RECEIVE AND FILE COMMUNICATION FROM THE PLAN AND ZONING COMMISSION REGARDING APPROVAL OF PRELIMINARY PLAT "CITYVIEW 34" FOR PROPERTY LOCATED AT 1331 KEOSAUQUA WAY

Communication from the City Plan and Zoning Commission advising that at their meeting held September 20, 2018, the following action was taken regarding a request from NJREC, Inc. (owner) represented by Nick Jensen (officer) for a Preliminary Plat "Cityview 35" for subdivision of the property into 35 townhome lots within an overall common outlot.

STAFF REPORT TO THE PLANNING COMMISSION

NJREC, Inc., Cityview 34, 1331 Keosauqua Way

Cityview 35
Des Moines, Iowa

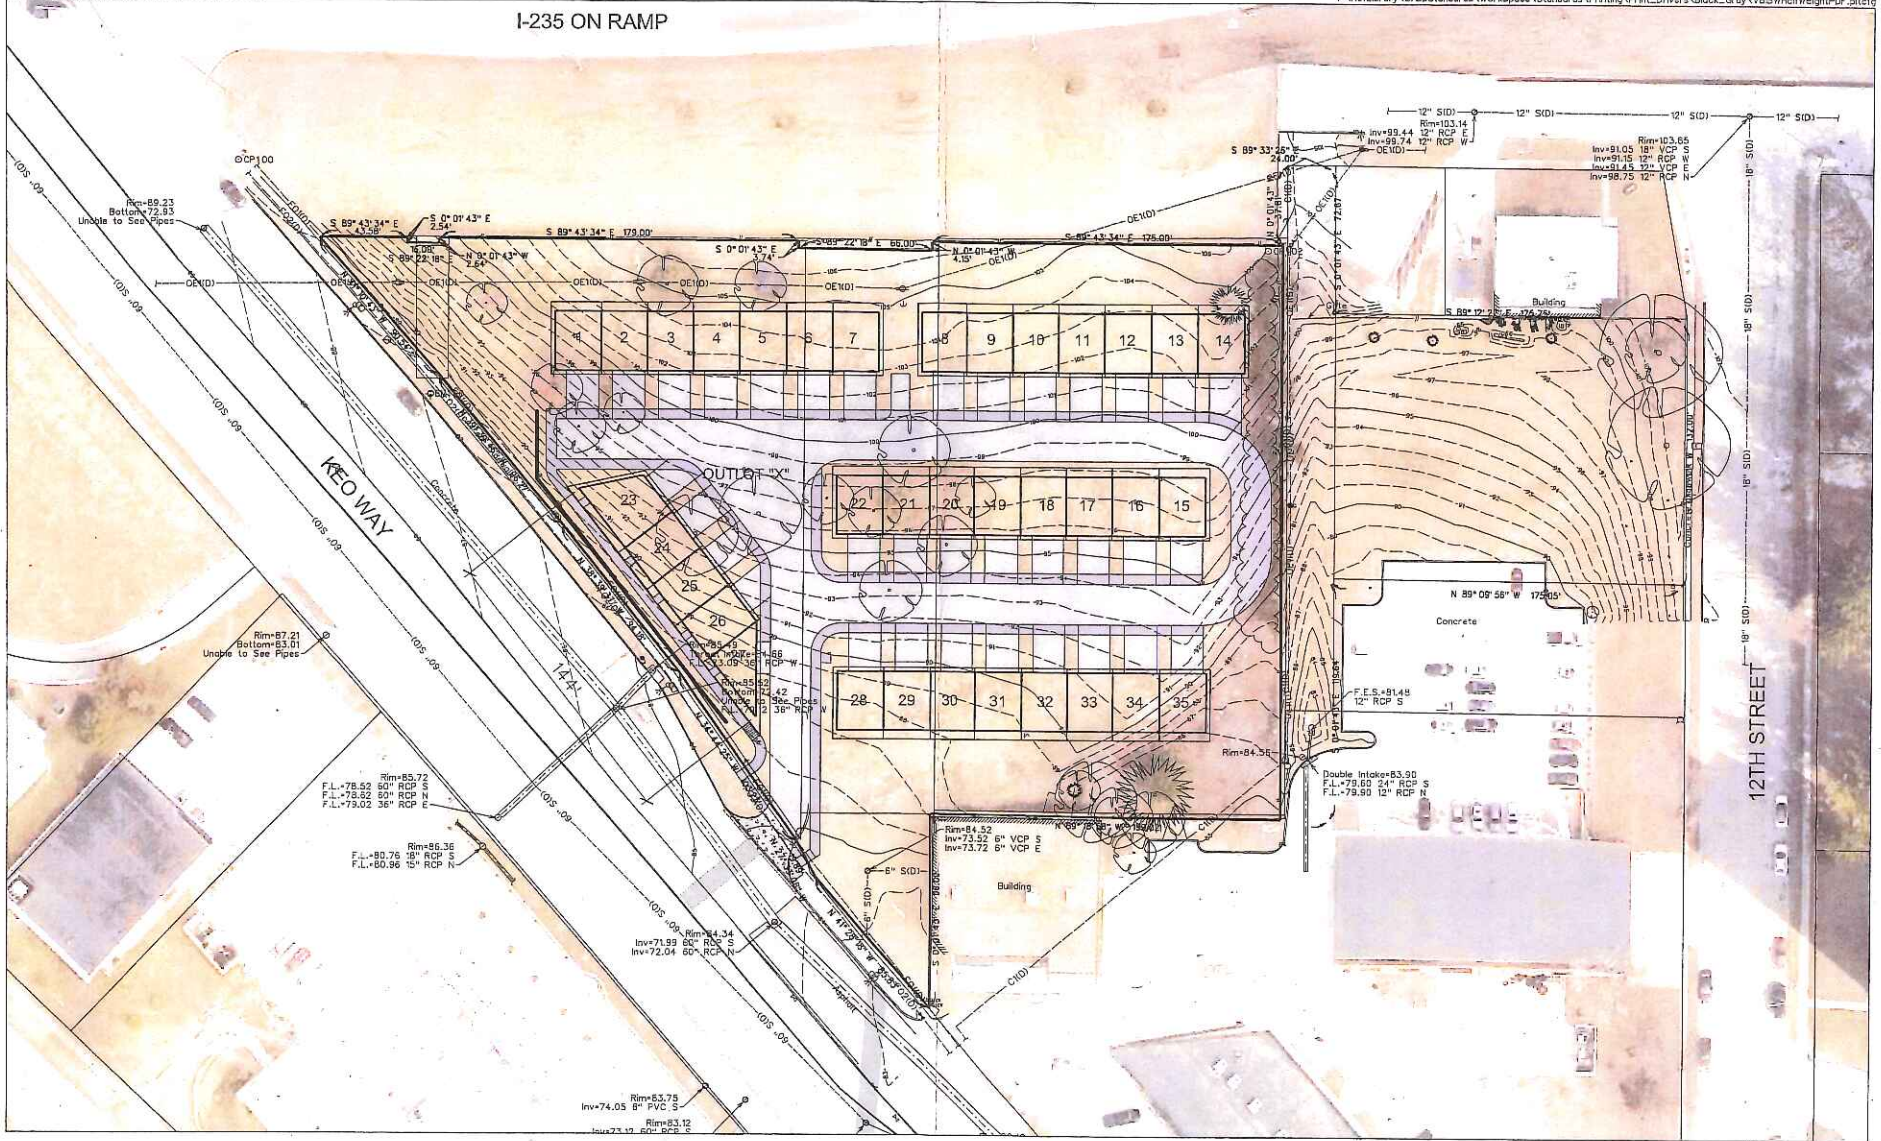
The proposed massing of 4 units along Keosauqua Way does not represent an urban level of massing along the street. The site has grade and shape challenges that make it not practical to line the entire street frontage with units. However, staff believes that 2 units could be added to the end of the group of 4 units along Keosauqua Way. This would require modification of the driveway into development and the planned storm water management facilities. This change would keep the total number of units the same by shifting the westernmost unit from the southern and northwest rows of buildings to the Keosauqua Way group. Staff believes that moving these two units to the street frontage will increase their desirability, particularly for the northwest unit since it would otherwise be near the Interstate 235 interchange.

The development would have frontage on Keosauqua Way. Four (4) of the 34 units are currently proposed to front the street. The units would setback 15 feet from the front property line. Street side doors are not proposed for these units. The submitted site plan and building elevations do not comply with this guideline. Staff believes that entrances to each unit should be provided that face the street.

The development would have frontage on Keosauqua Way. Only four (4) of the 34 unit would front the street. The units would setback 15 feet from the front property line. Street side doors are not proposed for these units. Staff believes that entrances to each unit should be provided that face the street.

The proposed massing of 4 units along Keosauqua Way does not represent an urban level of massing along the street. The site has grade and shape challenges that make it not practical to line the entire street frontage with units. However, staff believes that 2 units could be added to the end of the group of 4 units along Keosauqua Way. This would require modification of the driveway into development and the planned storm water management facilities. This change would keep the total number of units the same by shifting the westernmost unit from the southern and northwest rows of buildings to the Keosauqua Way group. Staff believes that moving these two units to the street frontage will increase their desirability, particularly for the northwest unit since it would otherwise be near the Interstate 235 interchange.

The site is located at a gateway into downtown. Staff believes that focal point landscaping should be provided at the northwest corner of the site along with at the entrance drive. Landscaping can also be used to offset the lack of building frontage along the street. Staff recommends approval subject to review and approval of the finalized landscaping plan by staff.

Bike racks are not noted on the site plan. Staff recommends that providing racks be a condition of approval.

The subject property has 490 feet of frontage along Keosauqua Way. The proposed development would occupy 19% of that frontage, which does not comply with this standard. The site has grade and shape challenges that make it not practical to line the entire street frontage with units. In addition, there is an access easement and sewer line at the southwest corner of the property that limit use of this portion of the site. Staff believes that 2 units could be moved to the end of the group of 4 units along Keosauqua Way. This would increase the percent of frontage occupy by a building to 28%. This is substantially short of the 70% standard, but staff believes this is a reasonable solution given site constraints.

Greg Wattier stated he is ok with striking condition #10 but feels it's important to build connections/stairs to units along Keo Way, not creating a raised separation along Keo Way.

Greg Wattier stated these units should have stairs from Keo Way.

Greg Wattier made a motion for approval of the submitted Preliminary Plat subject to the following conditions:

1. Review and approval of any adjustments to the plat layout that are necessary to comply with the conditions of the Site Plan approval by the Planning Administrator.
2. Compliance with all administrative review comments of the City's Permit and Development Center.
